Report of the CAA's Post Implementation Review of the London Airspace Management Programme (LAMP) Phase 1A Module E Airspace Change Proposal – South Coast Changes

CAP 1692 E

Published by the Civil Aviation Authority, 2018

This report is part of a series of PIR reports for LAMP Phase 1A Airspace change proposal implemented on 4 February 2016.

Clacton CTA & Worthing CTA (East) Proposed Base Changes

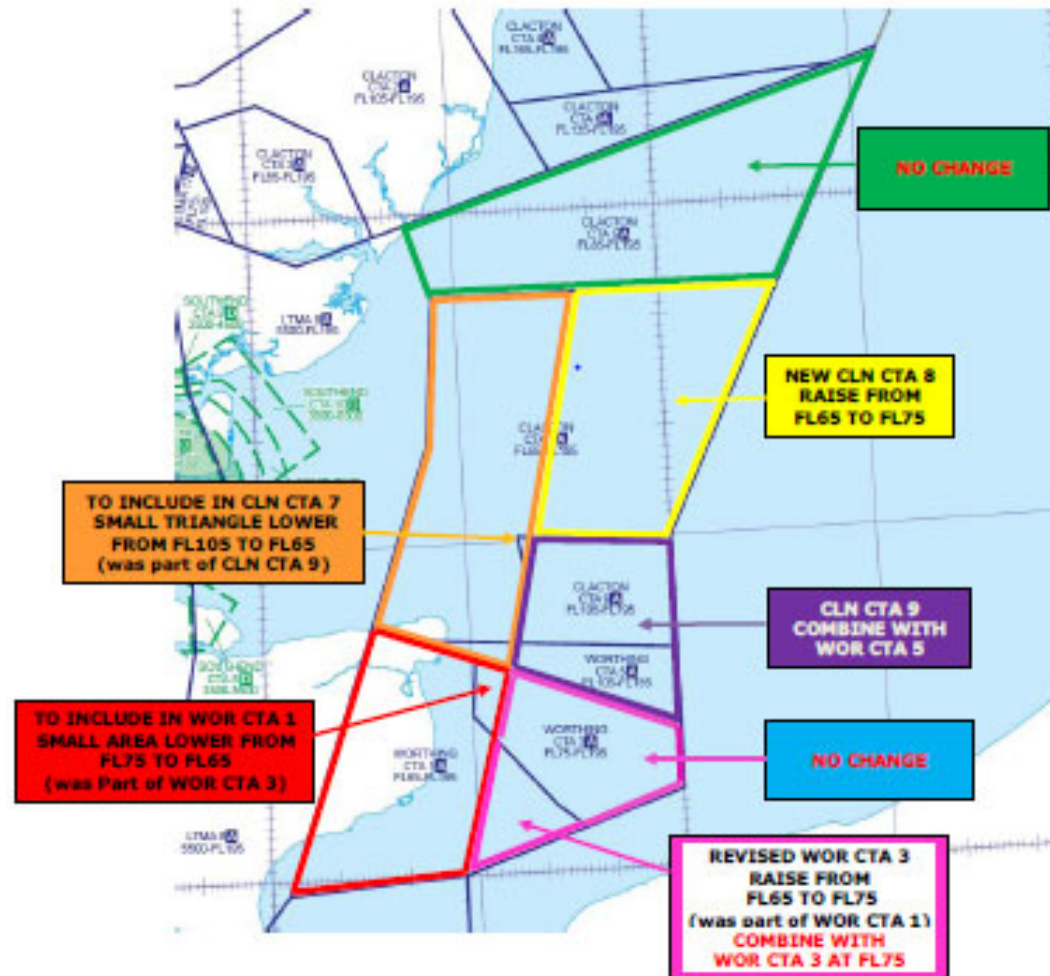
- 7 responses to date:
- 5 responses supported proposals but with some caveats:
 - Consider raising LTMA 14 to 5500ft – [CAA comment - not possible](#)
 - Pressurisation & icing issues; due time constraints, consider only raising up to FL 80 in short term until further analysis conducted – this allows for non-pressurised operations and caters for potential icing – [CAA comment – see following slide for possible option](#)
- One query raised - formal response pending
- NATS supplied a further option (3a) for south coast - still being considered by NATS:
 - Would raise only the southern part of WOR CTA 2 up to FL85 and
 - Would raise WOR CTA 6 up to FL85
 - [CAA comments – would now initially discount both options given pressurisation and icing issues – hence leave at FL75. Could just consider the minor adjustment to the WOR CTA 7 & 4 common boundary \(over the sea\)](#)

Worthing CTA (South) Option 2 Possible Revision to NATMAC Proposal

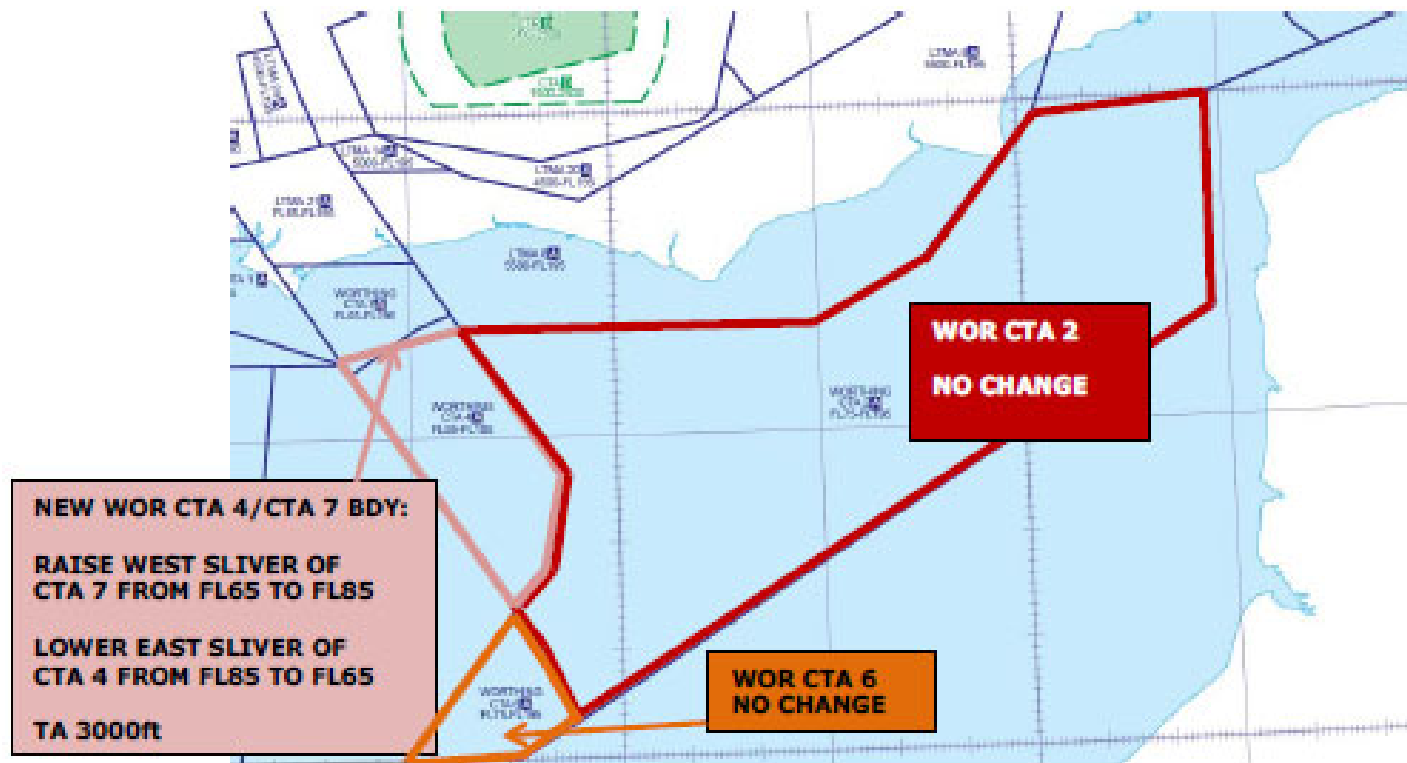
Possible Revision to NATMAC Proposal as at 27 Oct 16

Consultation Document Figure D 5 – Southampton typical arrival flows from the east to both runways 4000-7000ft.

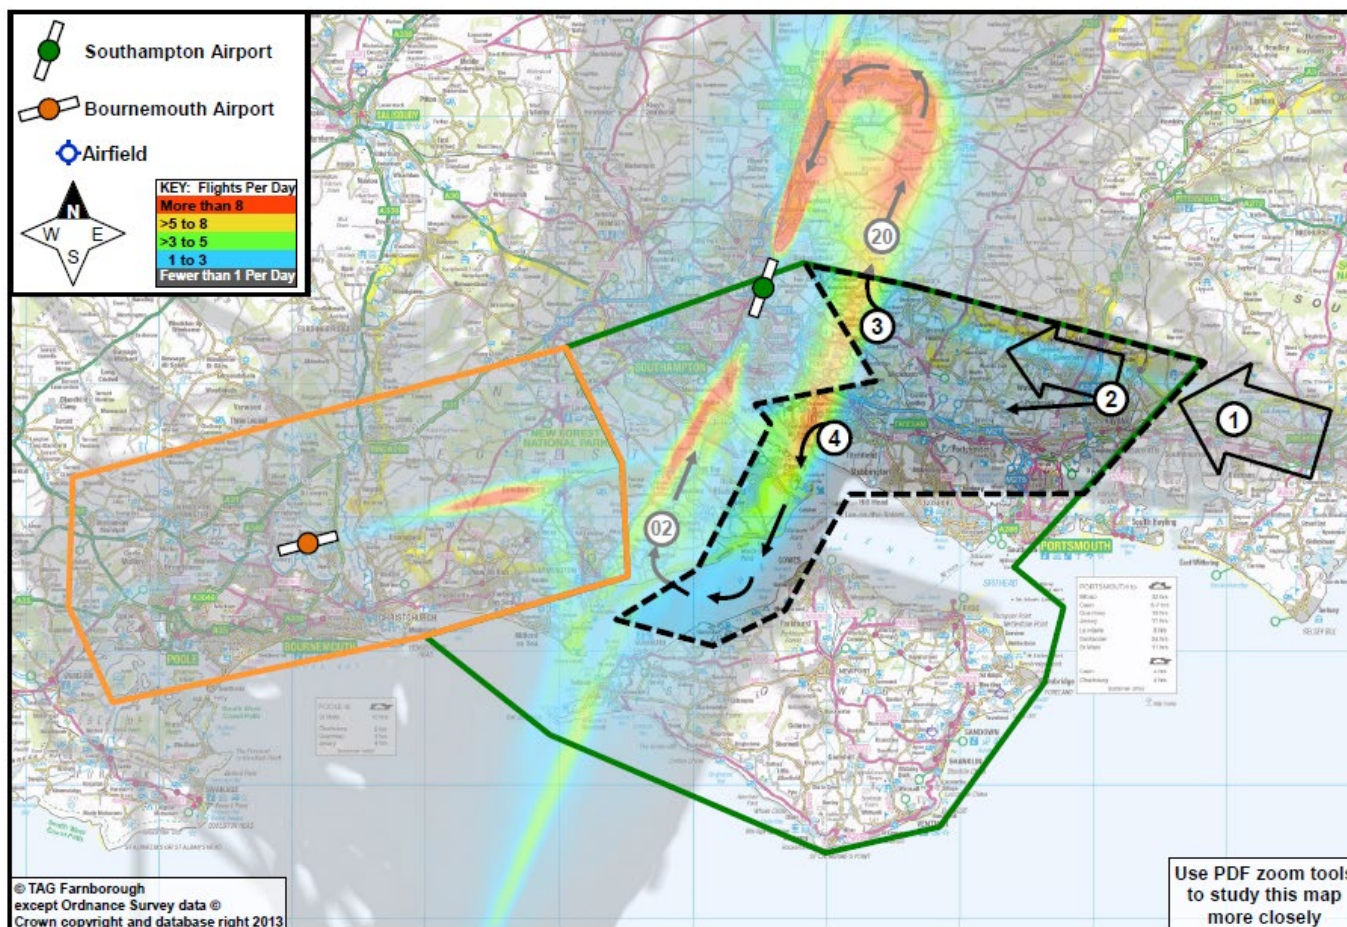
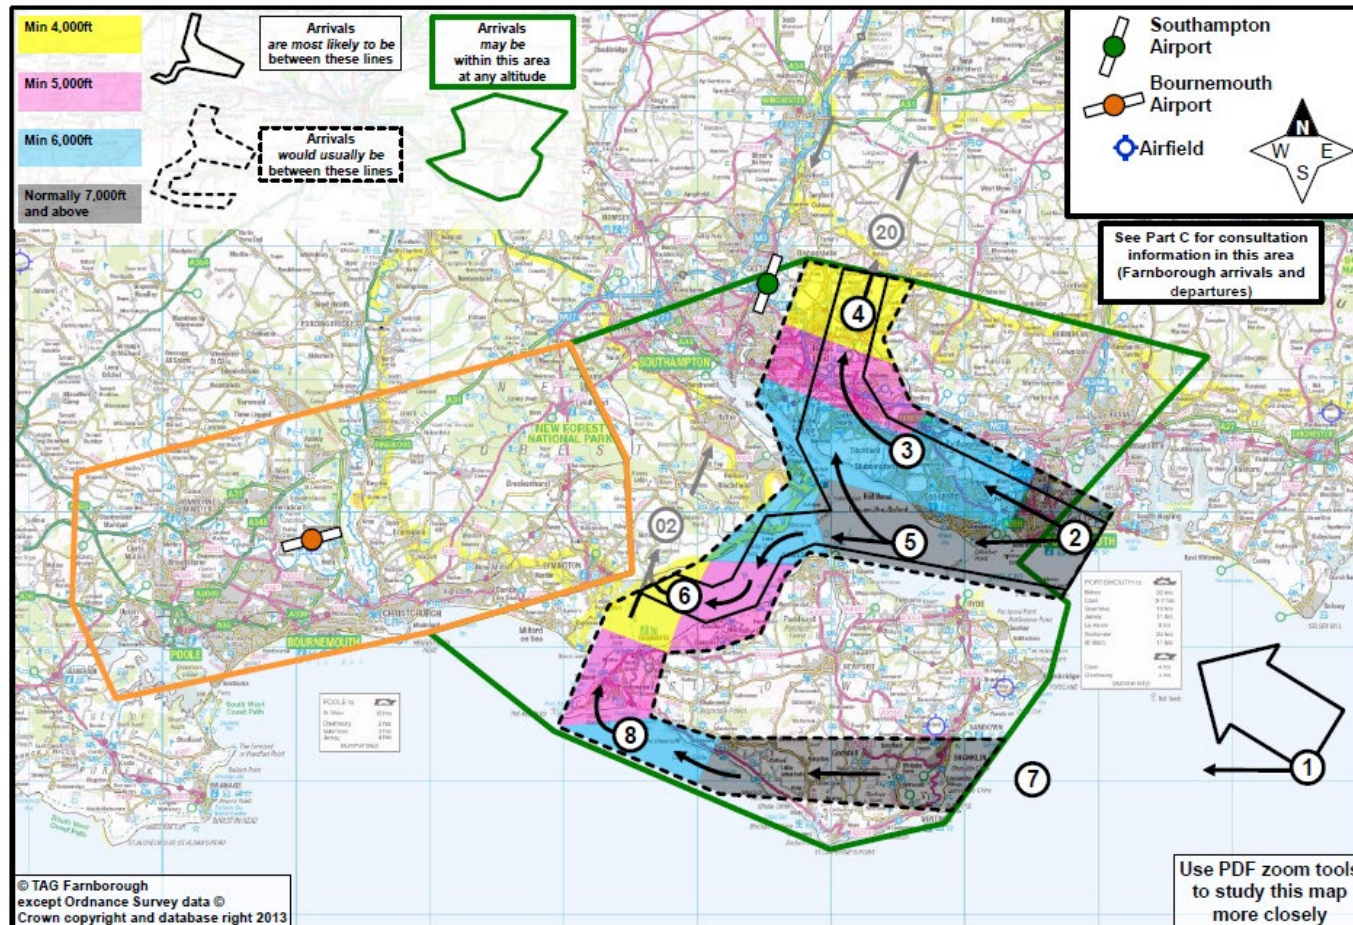
60. The impacts of the change have been as expected except that from the traffic sample provided, approximately 50% of the arrivals inbound to Southampton Runway 20 from the east are slightly further north than expected, overland rather than over the sea; this may either be due to the fact that arrivals are not

Track Analysis / ACP reference (a)	Anticipated impact as forecast in the ACP (b)	Pre-implementation Track Analysis 10-day sample period August 2015 (c)	Post Implementation Track Analysis 10-day sample period August 2016 (d)	CAA Remarks (e)
Consultation Fig D 8	<p>Consultation Fig D 8</p> <p>From the east traffic would route via points 1, 2, 3 and 4 or via points 1, 2, 5 and 4 for Runway 20, and via points 1, 2, 5 and 6 or via points 1, 7 and 8 for Runway 02.</p>	<p>ACP Fig 3 – arrival flight planned routes before implementation</p> <p>Solent Group arrivals from the east are in a swathe centred on the SAM 1D STAR as shown.</p> <p>PIR submission commentary Page 12/13 E01</p> <p>As shown by the diagram on page 12/13, the main flow of arrivals from the east is via Goodwood (GWC) and then just north of the Chichester Harbour AONB (Arrow 1); it splits after Arrow 2 (after passing the A3 M, and then follows either the direction indicated by Arrow 2 towards point 3 to proceed downwind for Runway 26 or towards point 4 to proceed downwind for Runway 02.</p>	<p>PIR submission commentary Page 14/15 and gate analysis on Pages 16&17 E01</p> <p>As shown by the diagram on pages 14 - 17 (Page 15 can be used to compare with the Consultation Fig D8 to illustrate what was forecast), we describe the traffic patterns provided for analysis.</p> <p>Runway 20 arrivals:</p> <p>instead of following the pre-implementation route described in column (b) routeing either over Portsmouth, north of Gosport towards Junction 9 of the M27, or via Portsmouth south of Gosport along the Solent before turning north towards Locks Heath heading towards Point 4 for Runway 20, after passing Selsey Bill, the arrivals are following a variety of traffic patterns:</p> <p>1. Approximately 50% of arrivals are being routed slightly further north of the intended track passing further north of Portsmouth over Hilsea, north of Porchester following the alignment of the M27 and then remaining north north of the</p>	<p>The traffic pattern using the more northerly route inbound to Southampton Runway 20 was not as predicted.</p>
